# pse\_dll\_power\_type

# pse\_power\_type Phrasing Indicative of Overwhelmed Variable

Figure 33-31—Type 1 and Type 2 PD state diagram

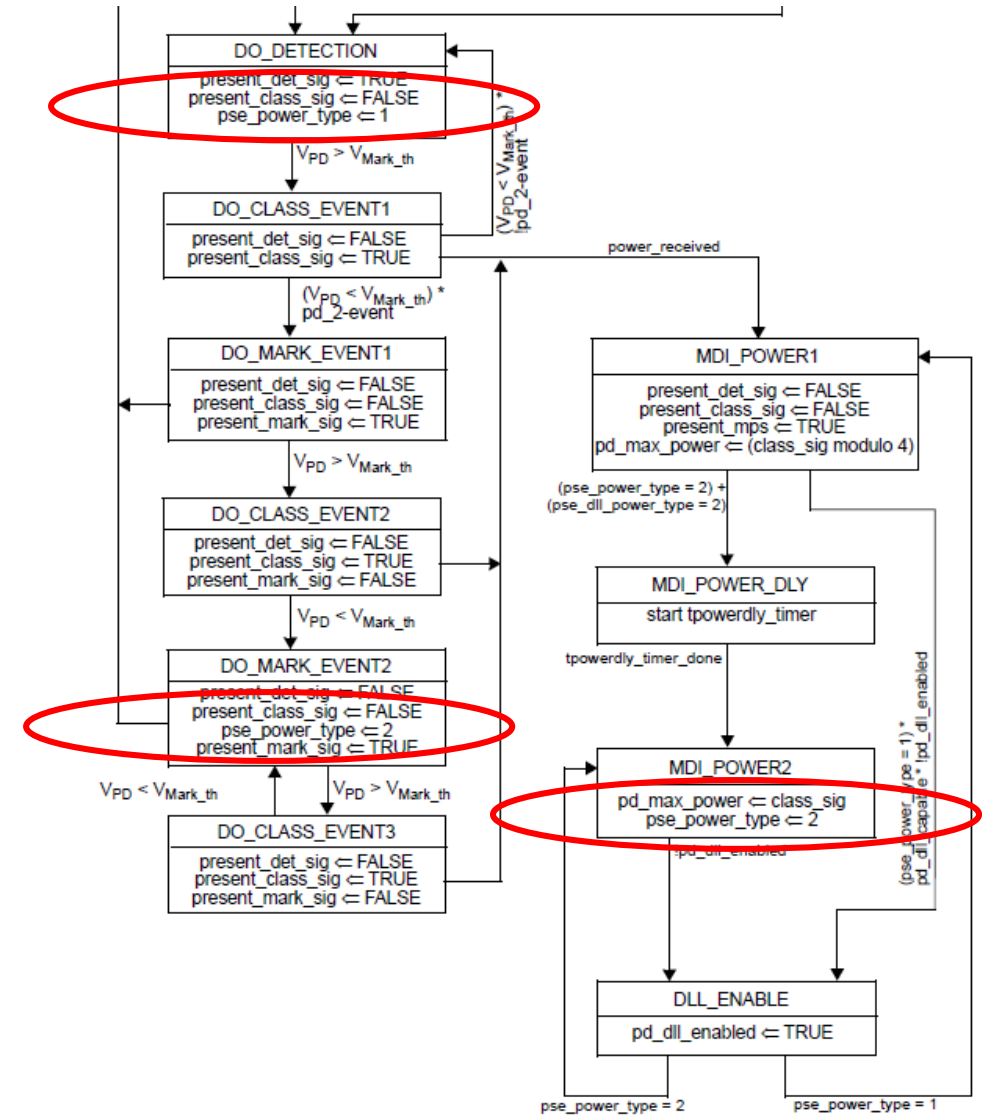
- pse\_power\_type is used to inform the DLL via the Power Control SM of the attached PSE's Type (1 or 2)

Figure 33–32—Type 3 and Type 4 single-signature PD state diagram (continued)

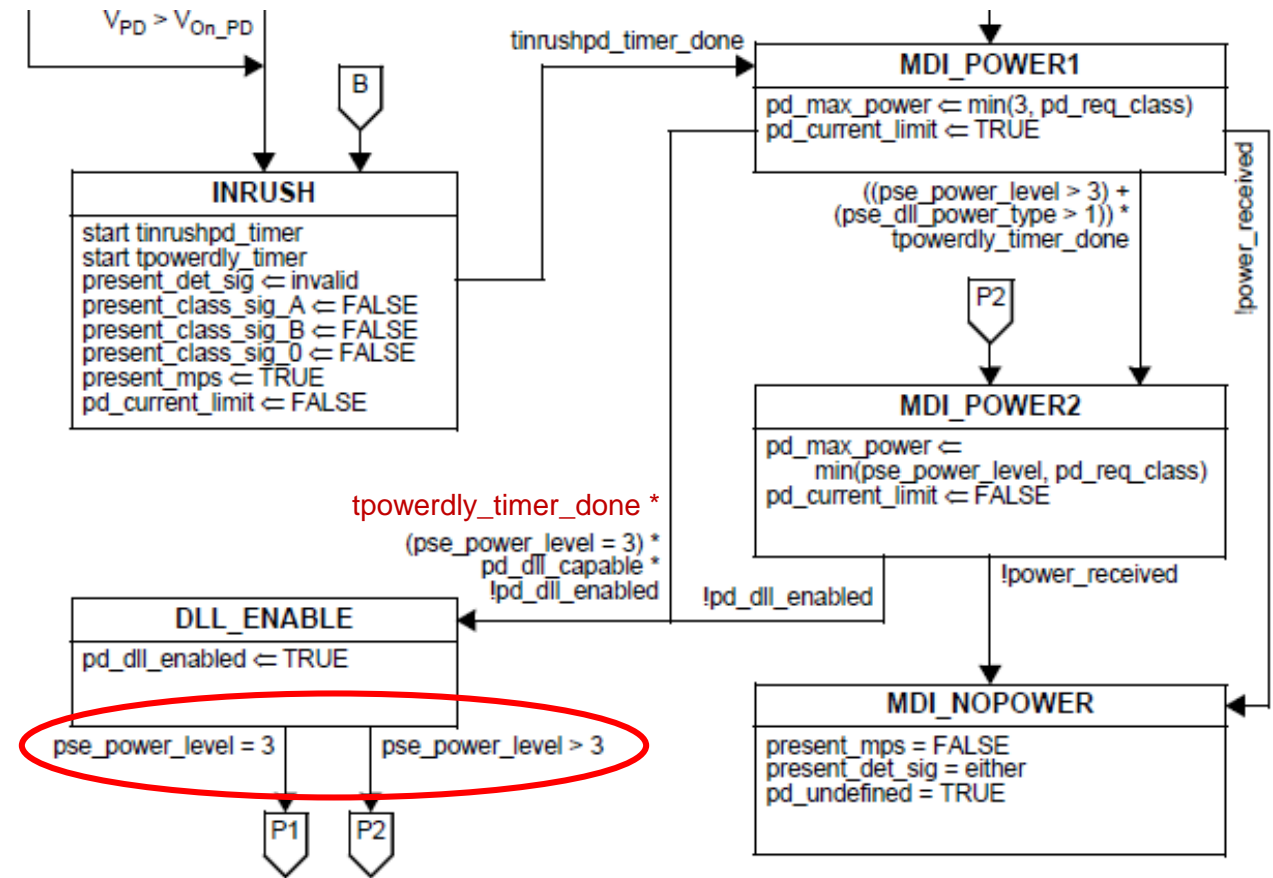
- tpowerdly\_timer should block DLL\_ENABLE (thus MDI\_POWER2)
- pse\_power\_level is the analogue of the Type 1/Type 2 PSE pse\_power\_type
  - pse\_dll\_power\_type of D2.0 is incorrect

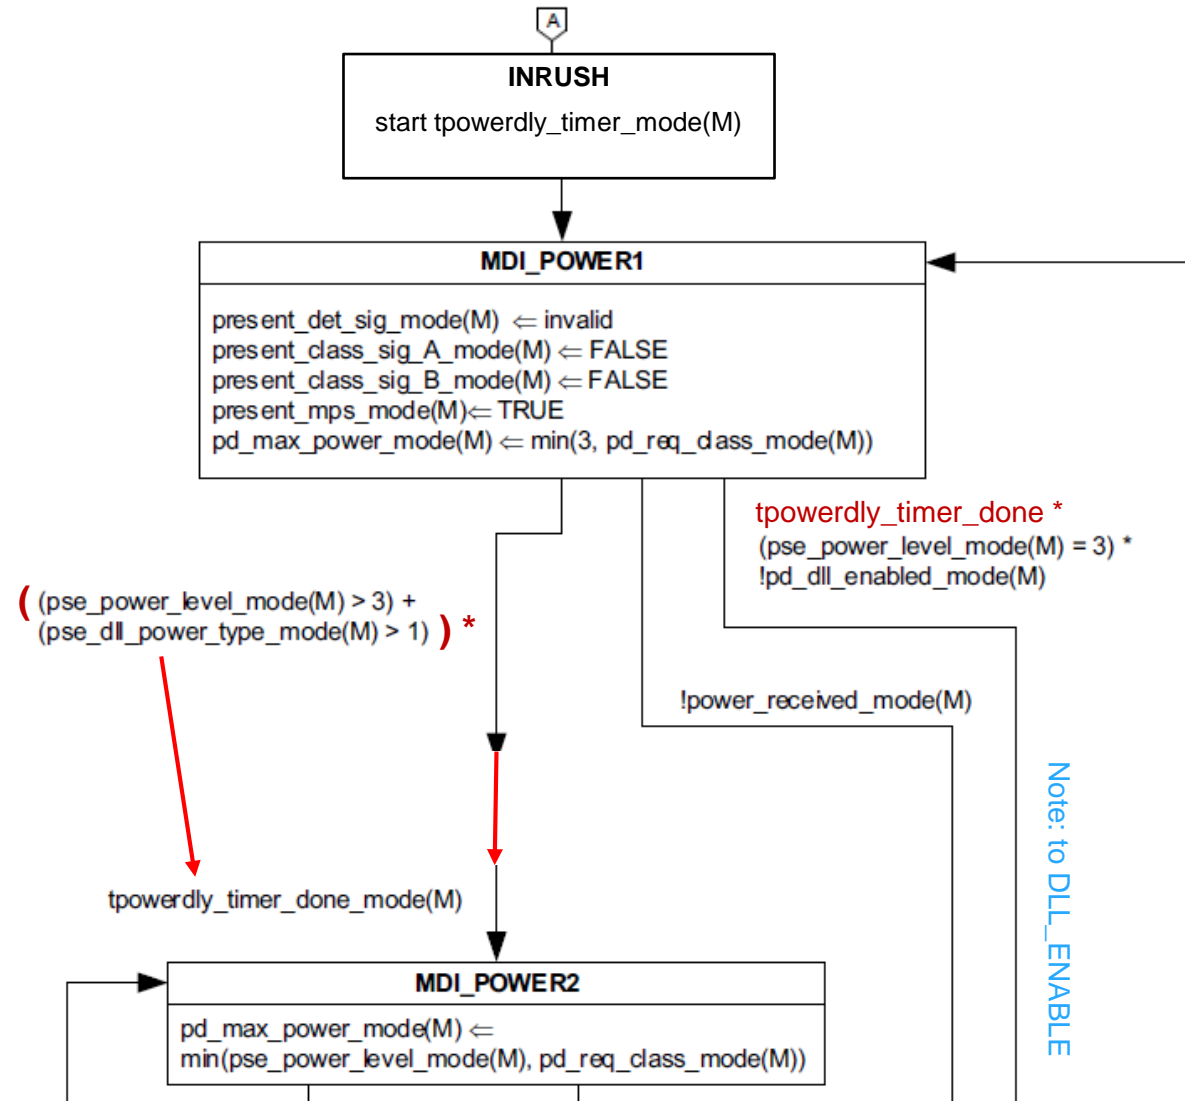
- MDI\_POWER\_DELAY can collapse out (per YD #83)
  - Needed for rest of solution thus repeated here
- tpowerdly\_timer should block DLL\_ENABLE (thus MDI\_POWER2)

Figure 33–33—Type 3 and Type 4 dual-signature PD state diagram (continued)

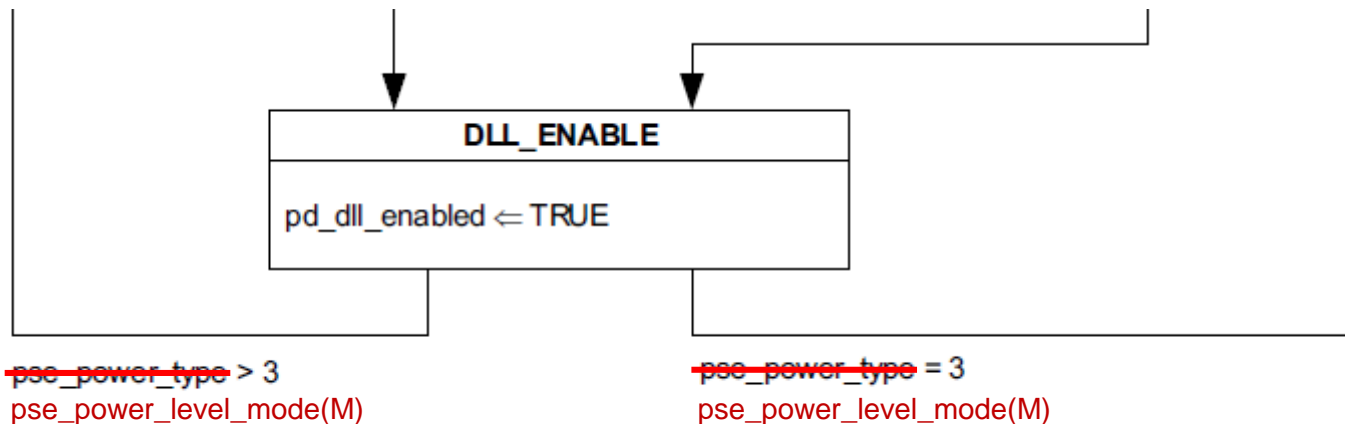
- Per YD #69
  - pse\_power\_type should be pse\_power\_level\_mode(M)
  - pse\_power\_level\_mode(M) is the analogue of the Type 1/Type 2 PSE pse\_power\_type

Figure 33-49—PD power control state diagram

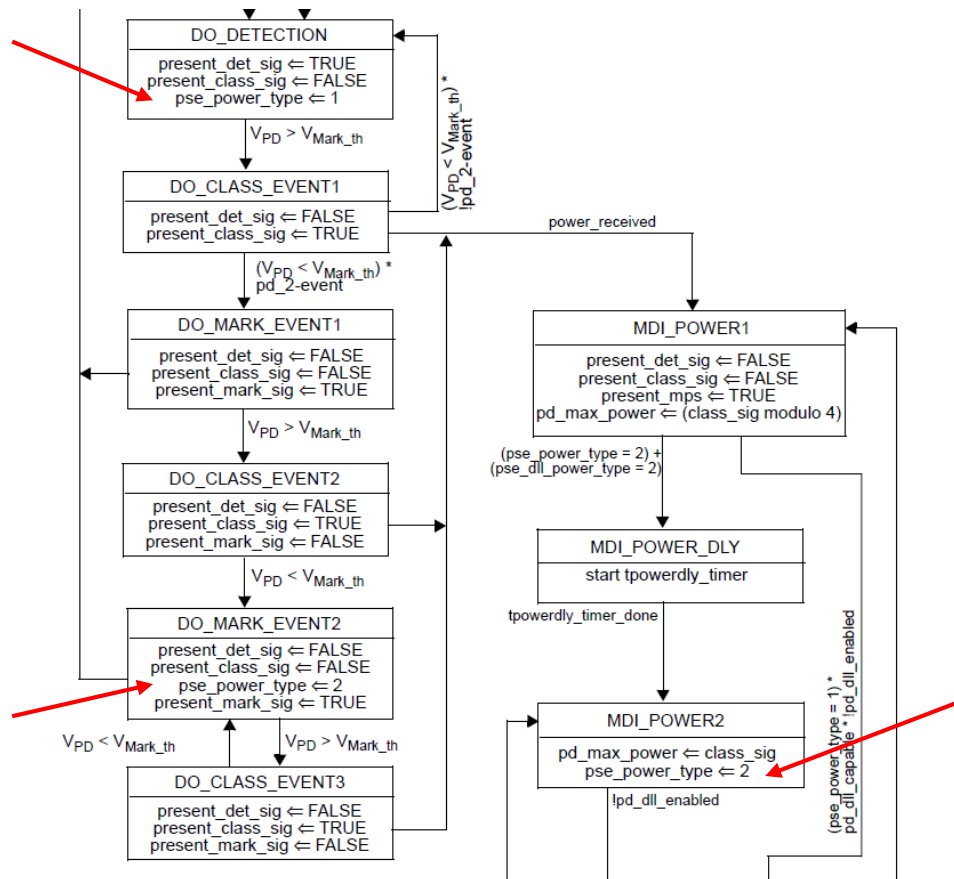
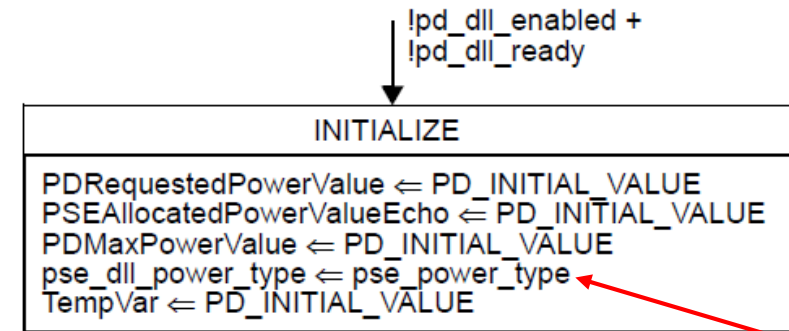
- pse\_power\_type is undefined for Type 3/Type 4 PDs
- Instead pse\_power\_level and pse\_power\_level\_mode(M) exist

Unsure of best solution...

Figure 33-48—PSE power control state diagram

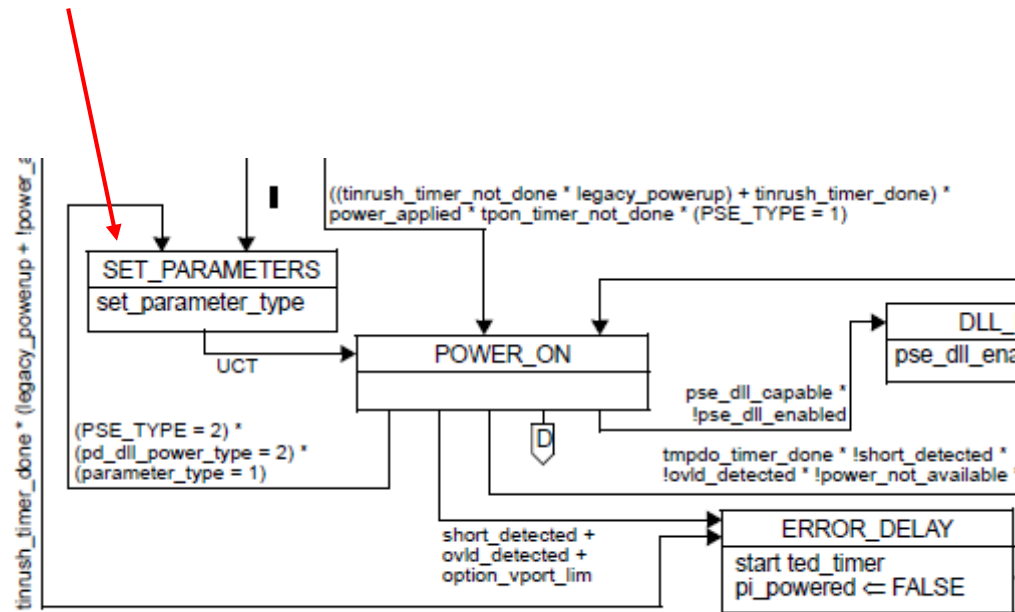
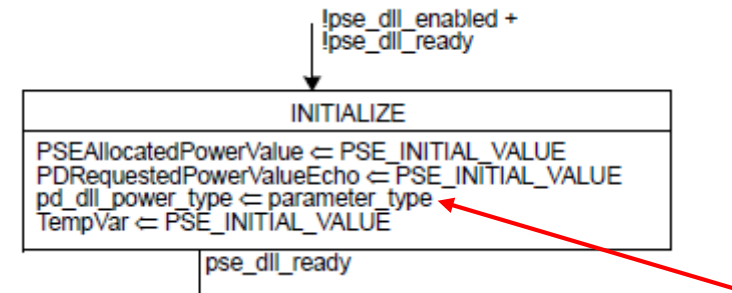
- parameter\_type is undefined for Type 3/Type 4 PSEs
- Unsure of best solution...
